Item H-1

Consider a resolution approving a Site Plan Amendment with variances for First Baptist Church, situated on approximately 7.97 acres, being legally described as Lot 1R1A, Block 3 of the Johnson Addition; Lots 5-11, Block 2 of Johnson Addition-Keller; Lot 1, Block 1 of Cagle Addition; Tracts 1C01B, 1C01A, 1J, 1L, 1F, 1G, 1C02, 1H1, 1H2, 1H, 1I, 1K, 1I1A, 1K1A, Abstract 1171 of the Samuel Needham Survey and zoned Single-Family 8,400 square-foot minimum lot sizes or greater (SF-8.4) and Old Town Keller (OTK), and addressed as 218, 220, 224 and 245 Lorine St; 237, 231, 221, 217, and 213 Jessie Street; 222 and 238 Ruby Street; and 145, 205 and 211 Pearl Street. First Baptist Church, Owner/Applicant (SP-22-0027)

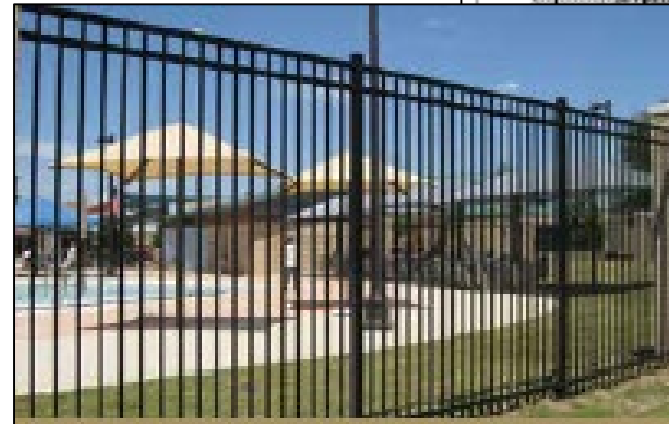
Per UDC Section 8.08 (F)(3), if proposed parking spaces exceed the required number by 10%, 50 square-feet of additional landscaping shall be required per parking space.

The Applicant is exceeding parking requirements by 85 spaces. This equates to 4,250 square feet of additional landscaping, which the Applicant has added to the site plan.

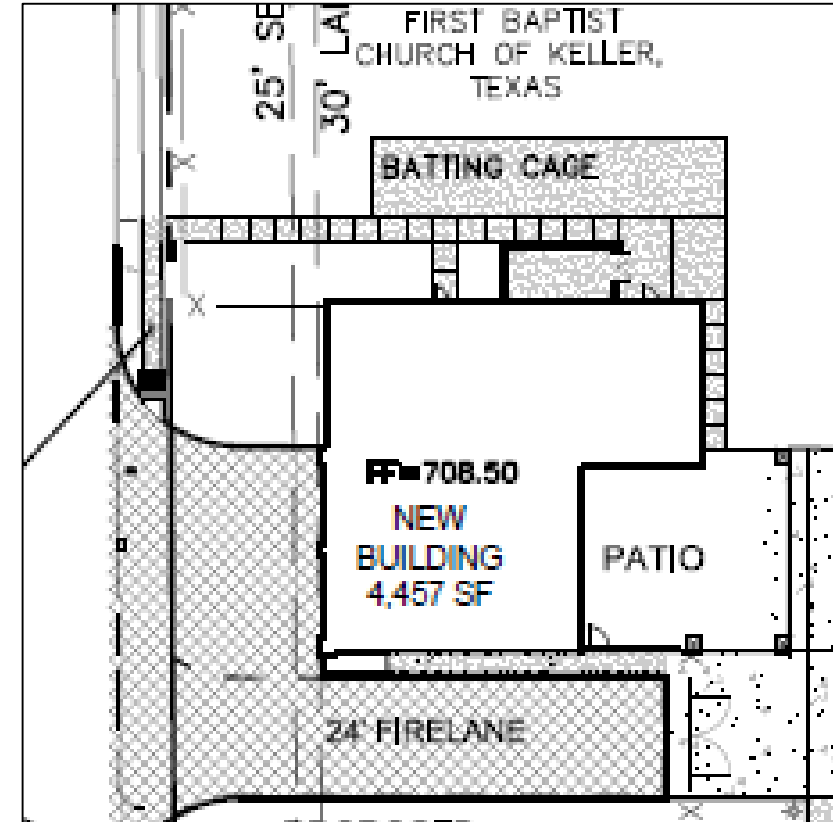
Garage door exposure and driveway: VARIANCES REQUESTED

The proposed 4,457 square-foot accessory building includes a garage that faces Jessie Street.

UDC Section 8.07 (C) states that a garage door within 100 feet of a residential street shall not be larger than 72 square-feet. Each proposed garage door is 172 square-feet. The garage door exposure exceeds Code by 272 square-feet for both doors.

2. To allow 344 square-feet of garage door exposure to the street.

*The Planning and Zoning Commission asked – and the Applicant agreed – to enhance the garage door design to resemble carriage doors

Garage door exposure and driveway: VARIANCES REQUESTED

UDC Section 5.07 (B)(1)(b) states the maximum width of a non-residential two-way driveway is 30 feet. The Applicant proposes a driveway width of 70 feet, 2 inches to accommodate the oversized golf carts and the fire lane located on the south side of the accessory structure.

3. To allow a driveway width of 70 feet, 2 inches.

On September 27, 2022, the Commission voted to unanimously recommend approval with the condition of utilizing carriage-style garage doors facing the street due to the large size. The Commission also expressed appreciation to the Applicant for modifying the original site plan and reducing the number of variances requested from 13 to three.
